Stage 1 Road Safety Audit & Quality Audit including Walking and Cycle Audits

**Hodson Bay,
Waterfront Project**

***Hodson Bay, Barrymore,
Co. Roscommon***

**Figure 2 – Example Swept Path Analysis Bus Sheet 6 of 9
(31022-CIV-XX-XX-D-C-00400-Hodson Bay Vehicle Tracking Drawings)**

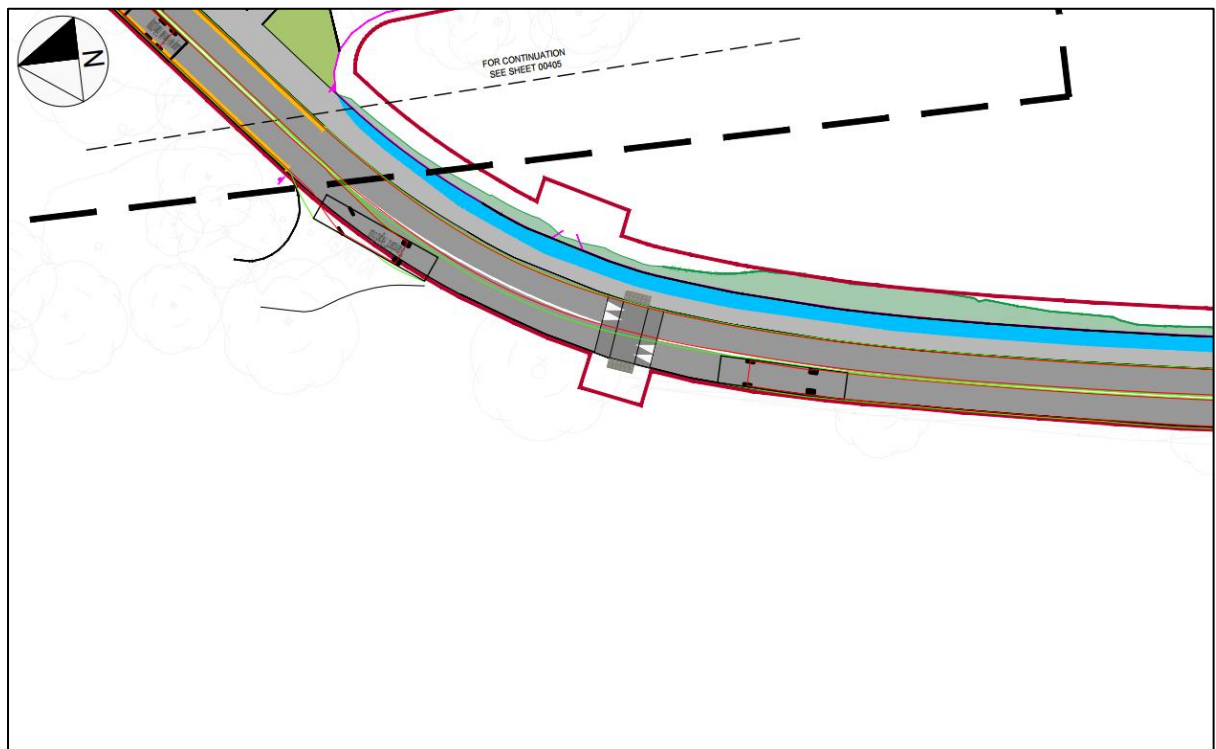
While the proposed narrowing of the carriageway is expected to reduce vehicle speeds, larger vehicles, particularly buses, may overrun the centreline on tight bends due to their swept path and rear overhang. This could result in opposing vehicles being forced to take evasive action or lead to side-swipe or head-on collisions.

The carriageway widths should be reviewed, in particular at tight bends using swept path analysis. Where necessary, the road carriageway should be widened locally to accommodate the largest anticipated vehicle, while maintaining the traffic calming objectives of the scheme.

3.1	Yes	No	The proposed narrowing forms an integral part of the traffic calming strategy and is intended to reduce vehicle speeds within the scheme area. Vehicle tracking has been undertaken to confirm that two 15 m coaches can safely pass at all proposed carriageway narrowing locations. The existing sections of the L2020 that are outside the scope of the proposed works and are not being altered and will remain unchanged. Accordingly, the proposed layout is considered capable of accommodating the anticipated vehicle movements while maintaining the objectives of the scheme.	Yes

Figure 6 – Proposed Crossing Width

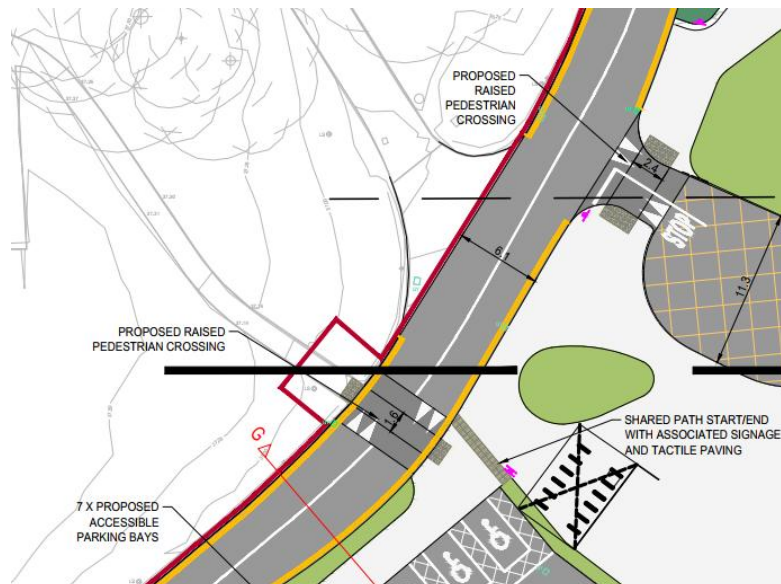
The existing footpath and pedestrian crossing are insufficiently wide to accommodate the anticipated pedestrian demand. The proposed raised crossing provides a flat-top width of only 1.6 m, which may result in pedestrians stepping onto the ramped sections when crossing in groups or passing one another, resulting in trips and falls.

The flat-top section of the raised crossing should be widened, and the footpath should be widened locally at the crossing to provide sufficient space for pedestrians to cross safely and comfortably.

3.2	Yes	Yes		
3.3	Yes	Yes		
3.4	Yes	Yes		
3.5	No	No	The proposed crossing has been assessed in the context of anticipated pedestrian and cyclist demand, vehicle flows, visibility and proposed operating speeds, subject to approval of the Roads Authority. The crossing is located within a traffic-calmed environment incorporating raised crossing facilities and speed-reduction measures. Available visibility exceeds the required stopping sight distance for the design speed and vehicle movements are expected to occur at low speeds. Consequently, a controlled crossing is not considered necessary or proportionate at this location, and the proposed raised	Yes

Figure 7 – Existing Zebra Crossings

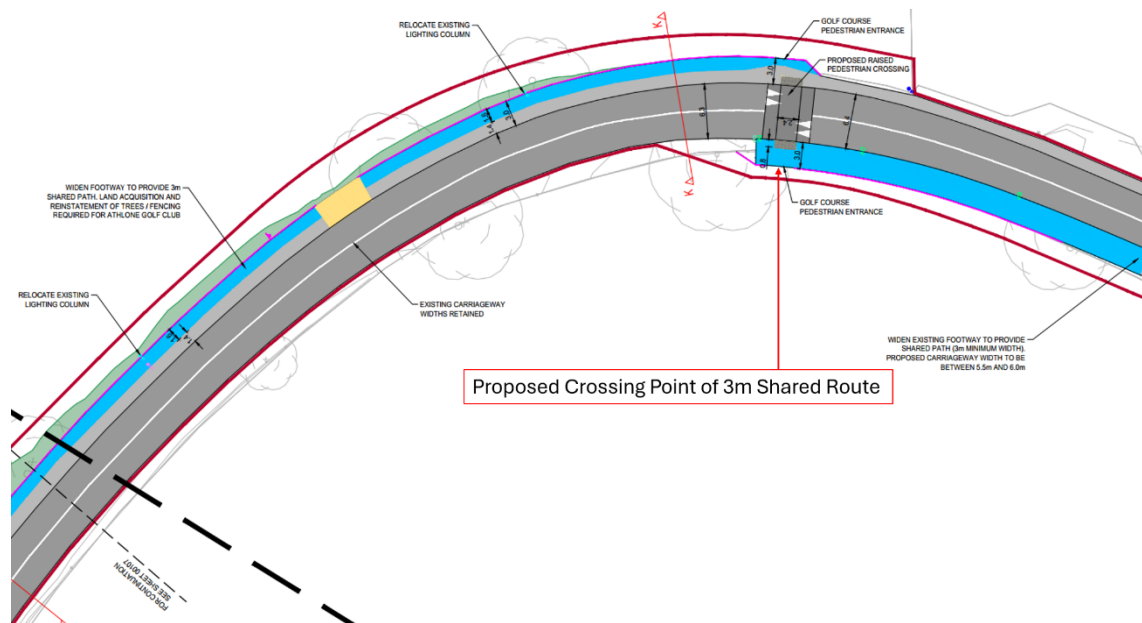
The proposed crossing point forms part of the 3.0m wide pedestrian / cycle route serving the development. However, it is unclear whether the proposed crossing provides an appropriate level of priority for both pedestrians and cyclists. In addition, visibility of the crossing on the vehicle approach appears restricted, which may reduce driver awareness of crossing users. This could result in conflicts between vehicles, pedestrians and cyclists, resulting in a collision.

The proposed crossing arrangement should be reviewed to determine whether a controlled crossing, such as a Zebra or Toucan crossing, is more appropriate. The crossing should safely accommodate both pedestrians and cyclists, reflecting the function of the active travel route. Given the restricted approach visibility, appropriate advance warning signage and road markings should also be provided to improve driver awareness of the crossing.

uncontrolled crossing is considered appropriate.	
3.6	Yes	Yes	The concern regarding the existing speed limit is accepted. Consideration will be given to a review of the existing speed limit on the L2020 in light of the proposed development, increased pedestrian activity and enhanced public realm environment. However, any amendment to the statutory speed limit is subject to the approval of the Roads Authority and is outside the direct control of this project. Notwithstanding this, the proposed scheme incorporates traffic calming measures, raised crossings and carriageway narrowing features which are intended to encourage lower vehicle speeds and improve safety for all road users

Figure 10 – Proposed Bus Route

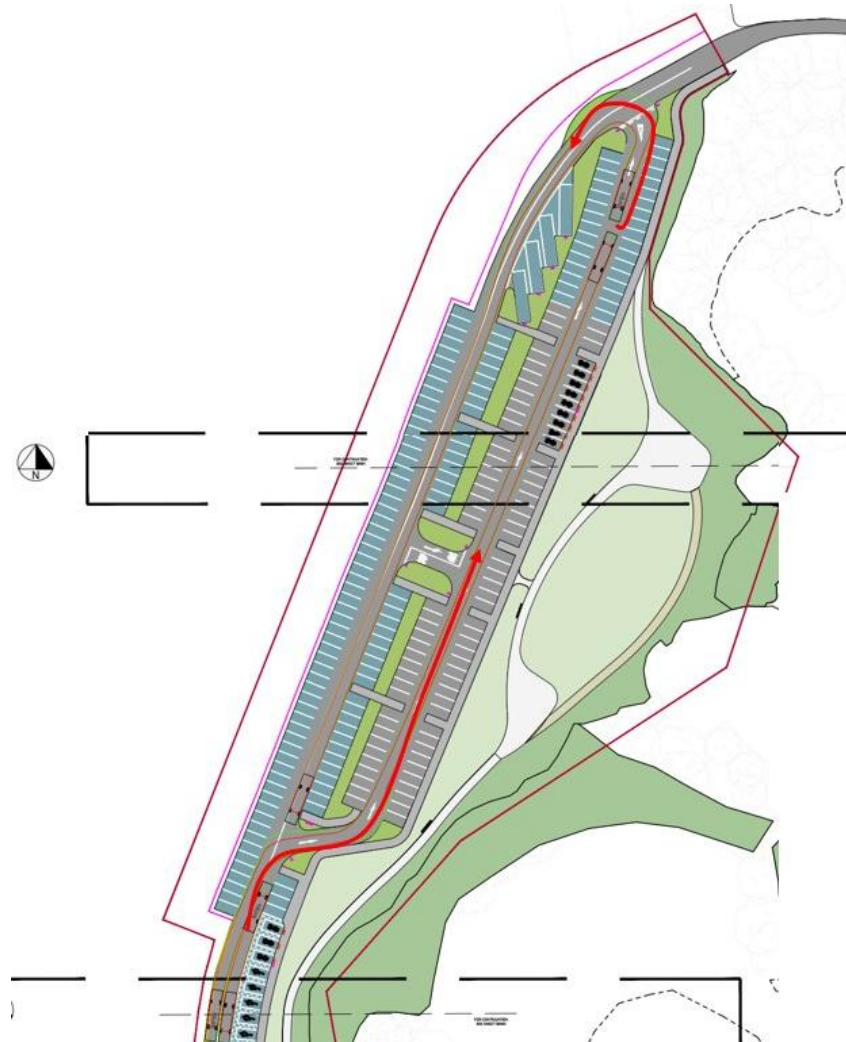
The proposed angled bus parking spaces can only be accessed if buses circulate through the site in an anti-clockwise direction. Should bus drivers fail to follow this route, there are limited opportunities for buses to turn around within the site, which may result in unsafe reversing or turning manoeuvres, increasing the risk of collisions with other vehicles, pedestrians and site infrastructure.

A comprehensive bus wayfinding strategy should be implemented throughout the site. Clear and consistent directional signage should be provided at all decision points to direct buses along the intended circulation route and safely to the designated bus parking areas. The internal layout should also be reviewed to ensure buses can safely manoeuvre in the event of driver error or missed turns.

3.8	Yes	Yes		
3.9	No	No	Dedicated coach pick-up and drop-off facilities are proposed immediately adjacent to the Watersports Pavilion and associated amenities. As such, coach passengers will be able to embark and disembark in close proximity to their destination without the need to traverse vehicular circulation areas. The northern coach parking spaces are intended solely for coach parking purposes, with no proposal for passengers to embark/disembark at this location. Consequently, the potential for pedestrian-vehicle conflict associated with passengers walking from the coach parking area to site facilities is significantly reduced. The proposed arrangement is therefore considered appropriate for the anticipated coach operations	Yes

Figure 12 – Proposed Raised Pedestrian Crossing

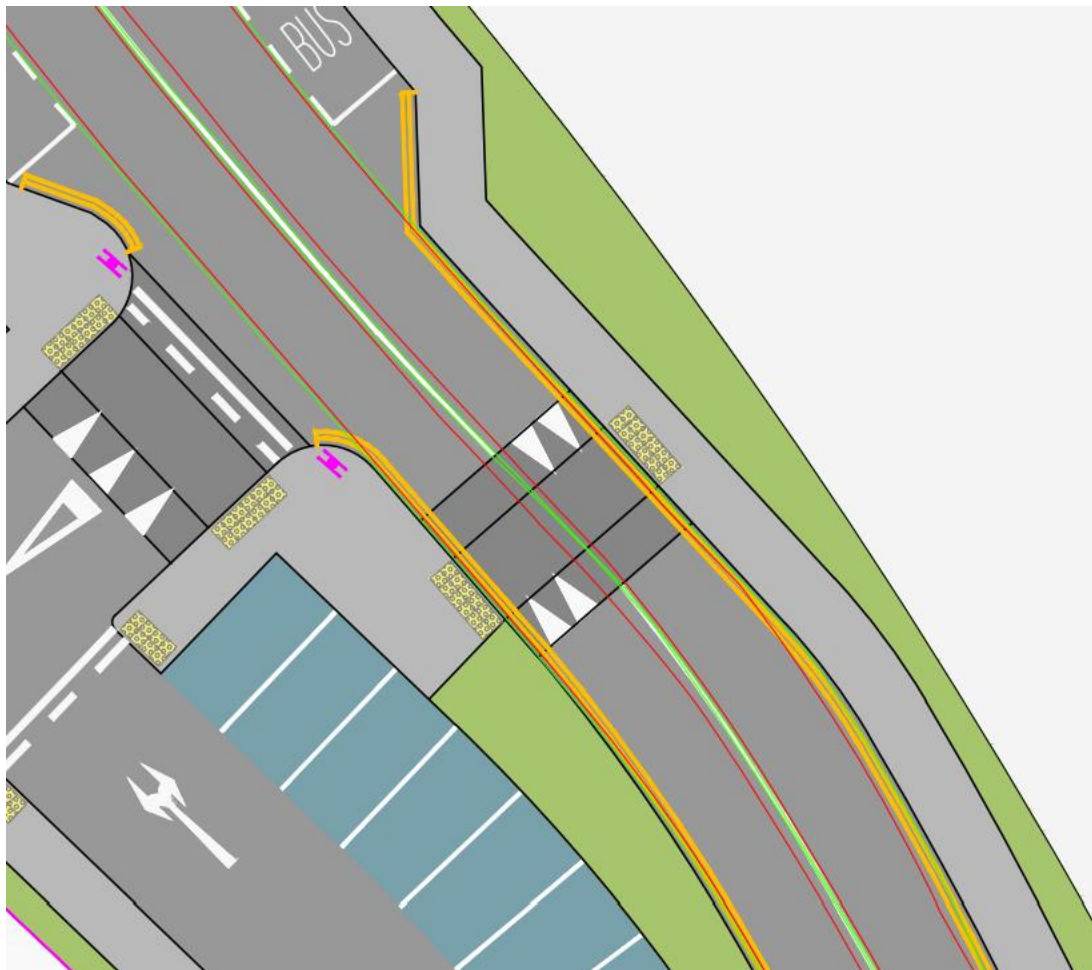
A significant number of buses were observed using the site. The proposed raised pedestrian crossings appear to incorporate relatively short flat-top tables. This may result in buses experiencing excessive vertical deflection when traversing the crossings, leading to discomfort for passengers and potentially encouraging drivers to brake sharply before, and accelerate after the crossings.

The raised pedestrian crossings should incorporate a minimum 6.0 m flat-top table to provide a smoother transition for buses while maintaining effective speed reduction and pedestrian priority.

3.10	Yes	Yes		
4.1	Yes	Yes		
4.2	Yes	Yes

Figure 13 – EV Charging Bays (Sheet 1 of 9)

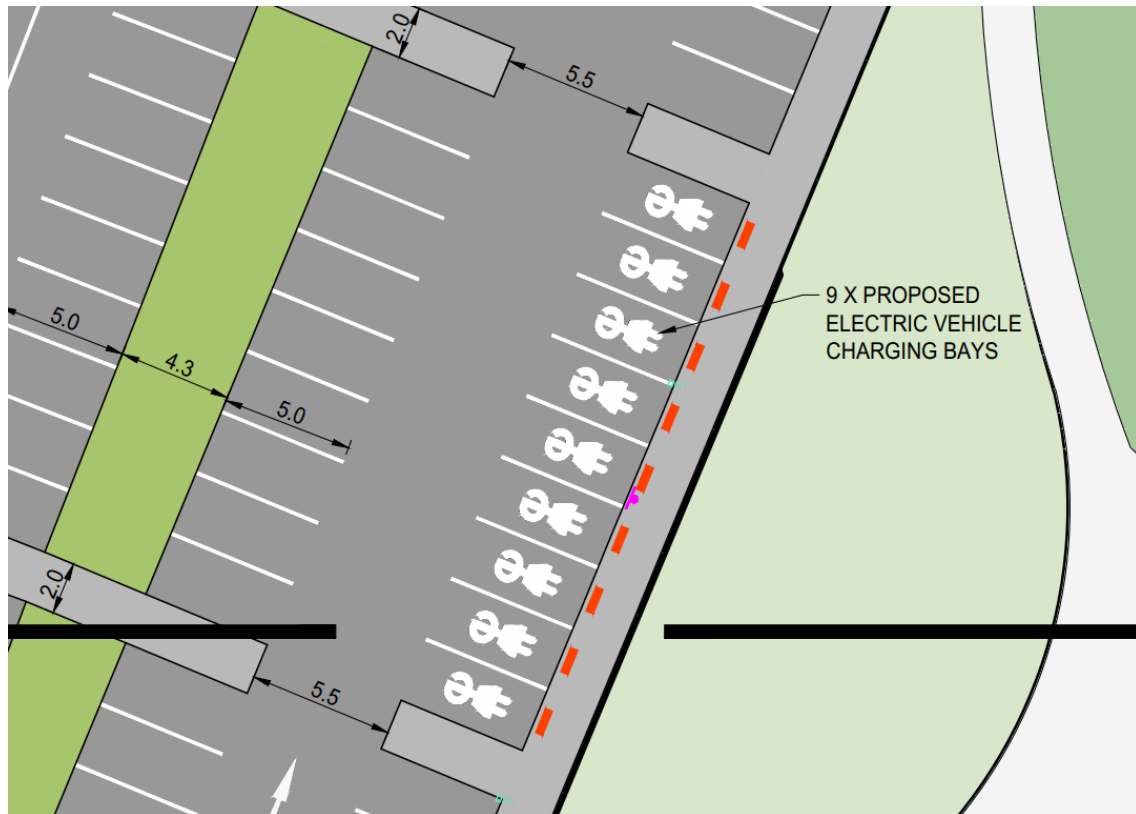
The proposed development includes a number of EV charging spaces; however, the associated charging equipment appears to be located within the pedestrian footway. EV charging units are often substantial in size, and charging cables may extend across pedestrian routes during use. This could obstruct the footway and increase the risk of trips and falls, particularly for visually impaired pedestrians and wheelchair users.

The EV charging equipment should be located outside the pedestrian desire line, with dedicated space provided adjacent to the parking bays to ensure the footway remains clear and unobstructed. The layout should be designed to minimise the potential for charging cables to encroach onto pedestrian routes during operation.

Figure 14 – Proposed end of Shared Route

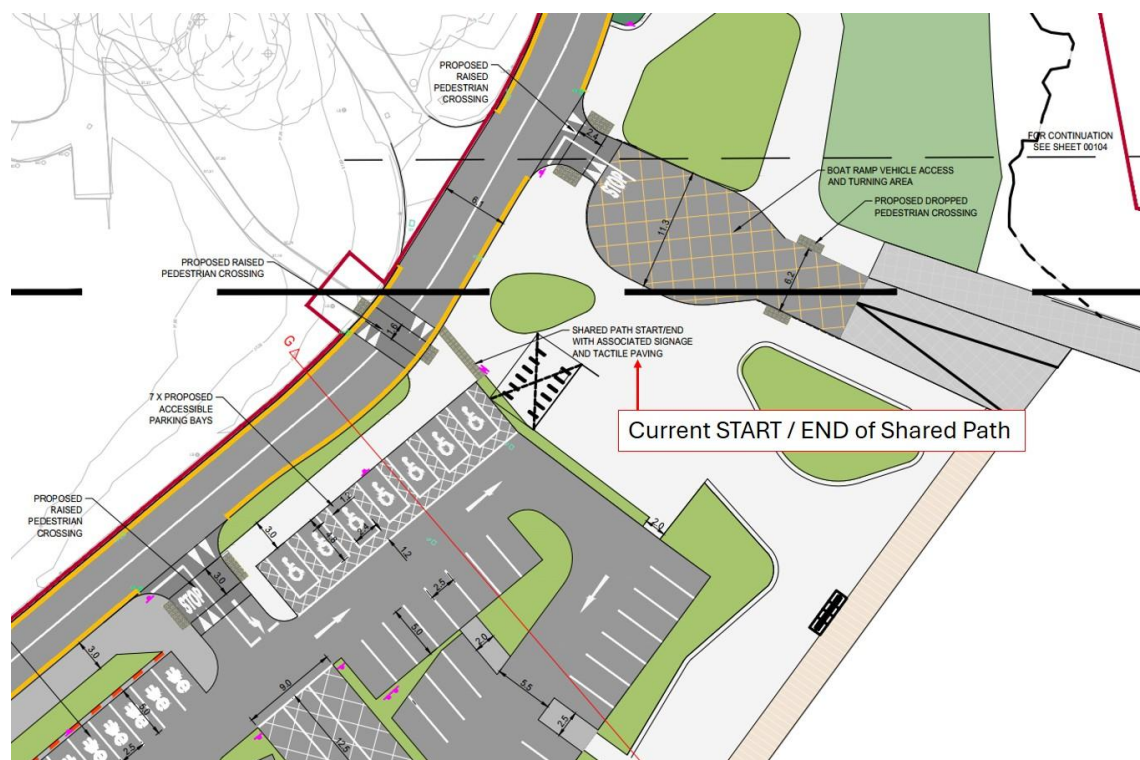
The proposed shared pedestrian/cycle path ends approximately 200m south of the proposed Water Sports Pavilion, despite the overall active travel scheme extending for approximately 1.6 km. Cyclists travelling to the Water Sports Pavilion are therefore likely to continue beyond the end of the shared facility. The remaining pedestrian routes are relatively narrow and may not safely accommodate shared use, resulting in conflicts / collisions between pedestrians and cyclists.

The shared pedestrian/cycle route should be extended to the Water Sports Pavilion. The connecting routes and crossing points should be designed to accommodate the anticipated levels of pedestrian and cyclist activity, with sufficient width provided to minimise conflicts between users.

5.1	No	No	The promenade is intended to operate as a pedestrian-only environment and is not proposed to accommodate cycling activity due to the anticipated high levels of pedestrian use and the constrained nature of the space". Cyclists will be directed to park at the marina cycle parking facilities before continuing on foot along the promenade or alternatively remain on the adjacent carriageway. Introducing cycling onto the promenade would conflict with the intended pedestrian function of the space	Yes

Figure 15 – Proposed Raised Pedestrian Crossing

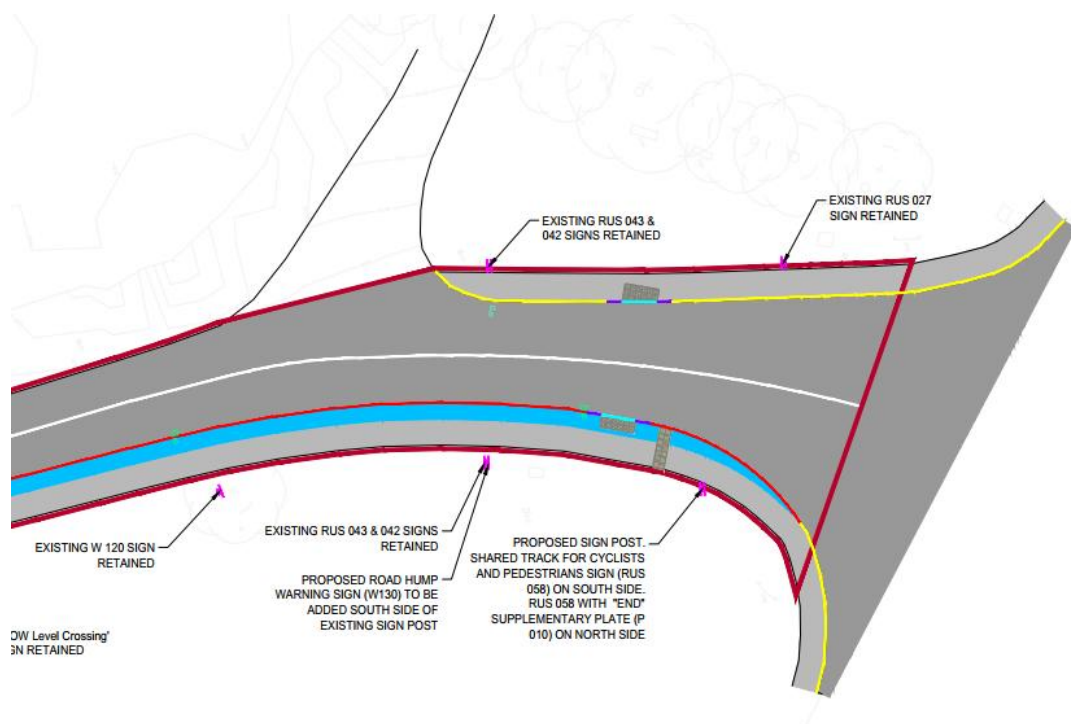
There is no dropped kerb or other transition arrangement shown to enable cyclists to safely enter or leave the proposed shared pedestrian/cycle path from the carriageway. It is therefore unclear how cyclists are expected to access the facility, which may result in cyclists mounting kerbs or joining and leaving the shared path at unsuitable locations, increasing the risk of loss of control or conflict with pedestrians and vehicles. In addition, the junction corner radii appear generous, which may encourage higher vehicle turning speeds and increase the risk of collisions with vulnerable road users.

The junction should be redesigned to provide appropriate transition arrangements, including dropped kerbs and flush connections, to facilitate the safe entry and exit of cyclists between the carriageway and the shared pedestrian/cycle path in accordance with the Cycle Design Manual. The junction corner radii should also be tightened to reduce vehicle turning speeds and improve safety for pedestrians and cyclists crossing the junction.

5.2	Yes	No	While the issue identified is acknowledged, the recommended alterations relate to the N61 junction and are outside the scope of the current project. Any changes to the national road network would require separate assessment and approval by TII. Opportunities to improve cyclist connectivity at this location may be considered as part of the future design and development of the Lough Ree Greenway	Yes

Figure 16 – Existing Vehicle Access Points

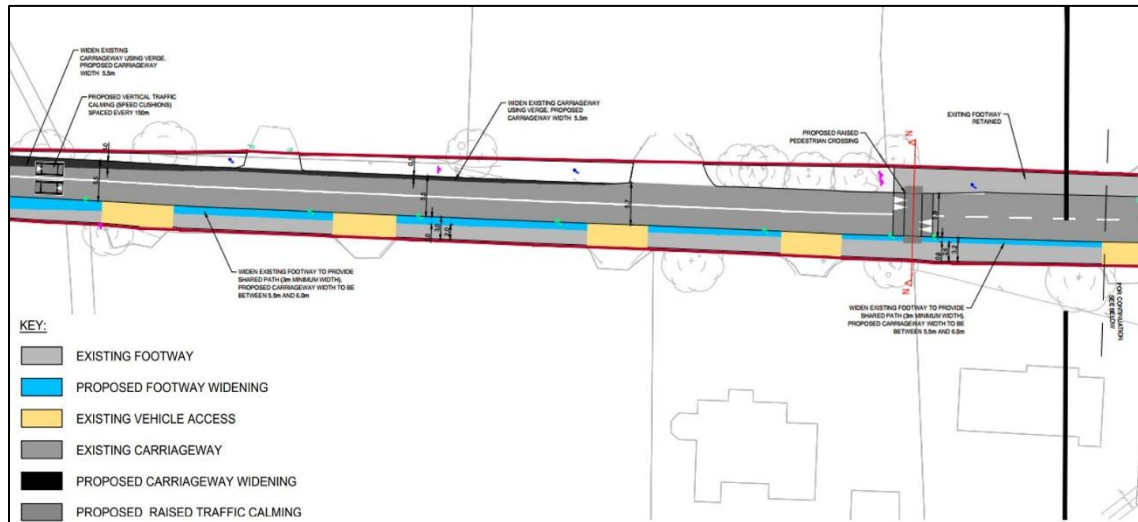
The treatment of the minor access crossing is unclear. If the shared pedestrian/cycle route is interrupted by kerbs or changes in level, pedestrians and cyclists may be required to give way unnecessarily or negotiate an uneven surface. This may reduce the attractiveness of the route and increase the potential for conflicts, loss of control by cyclists, and trips or falls.

The minor access should be designed as a continuous pedestrian and cycle crossing in accordance with the principles of the Cycle Design Manual. The footway/shared path should be carried across the access at a consistent level, with a bevel kerb provided to facilitate access for vehicles.

5.3	Yes	Yes		
5.4	Yes	Yes		
6.1	Yes	Yes		
6.2	Yes	Yes

Figure 18 – Car Parking

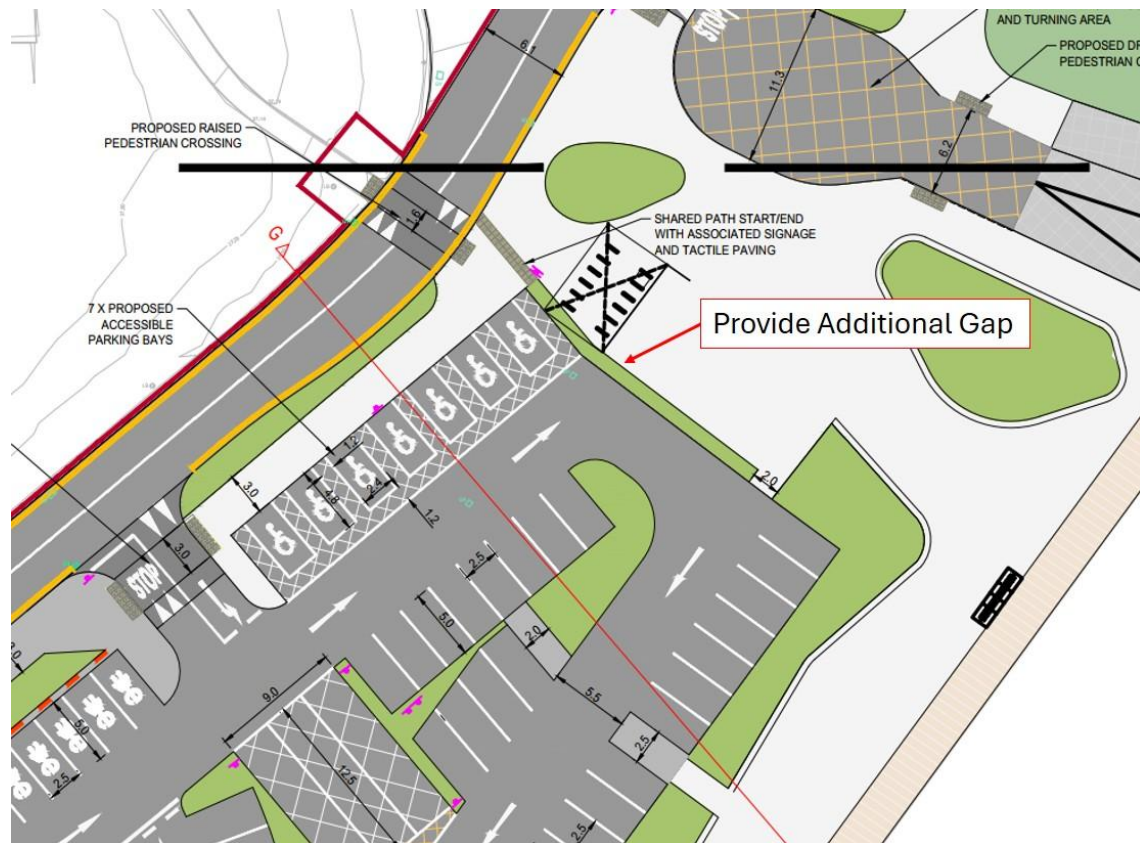
A large, shared pedestrian space is proposed adjacent to the car park; however, a landscaped strip separates the car park from the shared area, with only one direct pedestrian access provided to the south. As a result, pedestrians, particularly wheelchair users and those with reduced mobility, may be required to take indirect routes or cross the landscaped area, reducing accessibility and potentially leading to unsafe pedestrian movements through the car park.

A direct, accessible pedestrian connection should be provided between the car park and the shared space. The route should include a flush crossing point with dropped kerbs where appropriate, be fully accessible to wheelchair users and those with reduced mobility and align with the principal pedestrian desire lines.
